### XC18V00 PROM Errata and Deviations from XC18V00 Data Sheet

DS026-E01 (v1.1) March 10, 2004

Errata Notice

Figure 4: Recommended Resistor Value

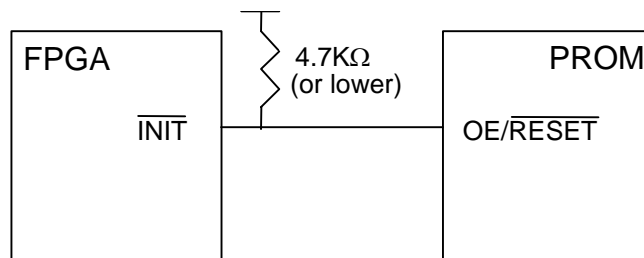
A pull-up resistor is required to properly propagate this signal through the PROM (Figure 1). Figure 2 shows a clean OE/RESET# (INIT#) signal. However, a slow ramp could potentially allow system noise to propagate through the PROM's input buffer (Figure 3), thus creating short reset pulses that might cause the internal circuits to get out of sync. The observed failure rate ranges from 1% to 5% of configuration cycles.

Follow the data sheet to ensure that an external 4.7KΩ (or lower) resistor is connected to the PROM's OE/RESET# pin and the FPGA's INIT pin. Ensure that the FPGA  $T_{ICCK}$  specification is met (500ns). This translates to a  $T_{RISE}$  and  $T_{FALL}$  time of 500 ns for the PROM's OE/RESET# signal.

Figure 8: (LED with Buffer Circuit)

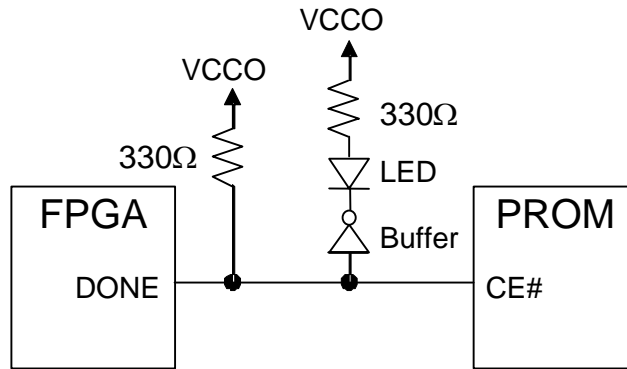
The FPGA has a sink current specification of 12 mA that is exceeded when an unbuffered LED is tied to the CE# (DONE) signal (Figure 5). In this scenario, the CE# (DONE) signal is held at an intermediate voltage level that mimics multiple input pulses (Figure 7). These pulses propagate through the PROM and cause the internal circuits to get out of sync. The observed failure rate is up to 50% of configuration cycles. Figure 6 shows a clean CE# (DONE) signal when it is not tied to an LED.

When using FPGA DONE to drive PROM CE# (to reduce standby power), make sure that the signal is within the specification and has a fast rise and fall time. Use an external buffer to drive any LED (Figure 8). If DONE is not used to drive CE#, it can be connected to an LED (Figure 9).

Figure 10: Asynchronous System

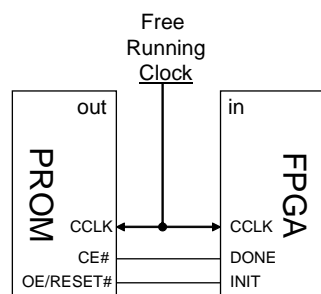
In most applications, the FPGA sources the CCLK signal, which synchronizes with the CE# (DONE) and OE/RESET# (INIT#) signals. However, in an asynchronous system (Figure 10), meaning when an external free-running clock drives the configuration clock signal (CCLK), there is a possibility that a missed or extra pulse (or pulses) can be interpreted by the PROM's internal counters as CCLK transitions while the OE/RESET# (INIT#) signal is in its intermediate phase (Figure 11). The observed failure rate ranges from 0.1% to 1% of configuration cycles.

There is no application work-around that will avoid exposure to the phenomenon when a free running clock is used. Therefore, customers who are using an external free-running clock need to convert their ordering code to SCD0799; this will ensure that they will not receive affected devices identified in Table 1, Table 2, and Table 3.

Figure 12: Counter Circuits

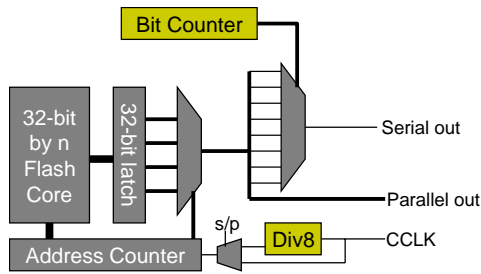
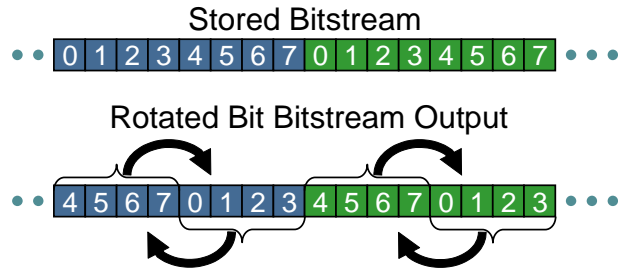
A Rotated Bit Pattern occurs when the Bit Counter and the Div8 circuit (Figure 12) becomes desynchronized. Data bits within a byte will be consistently rotated, byte by byte (Figure 13). Table 4 (above) summarizes the conditions where a Rotate Bit Pattern can occur.

Figure 14: Counter Circuits

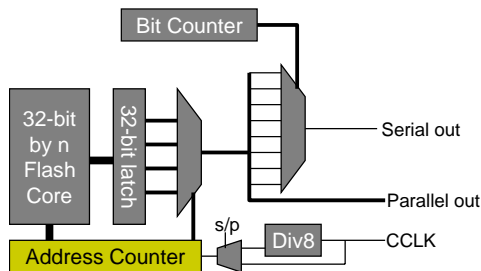
The Address Counter misses the first increment and repeats the first 32 bits. Table 4 (above) summarizes the conditions where an Extra 32 Bits pattern can occur.

Figure 16: Counter Circuits

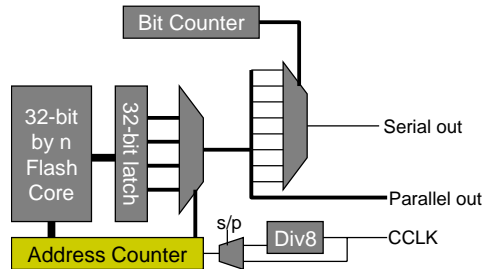
The Address Counter increments more than once and misses the second 32 bits. Table 4 (above) summarizes the conditions where a Missing 32 Bits pattern can occur.
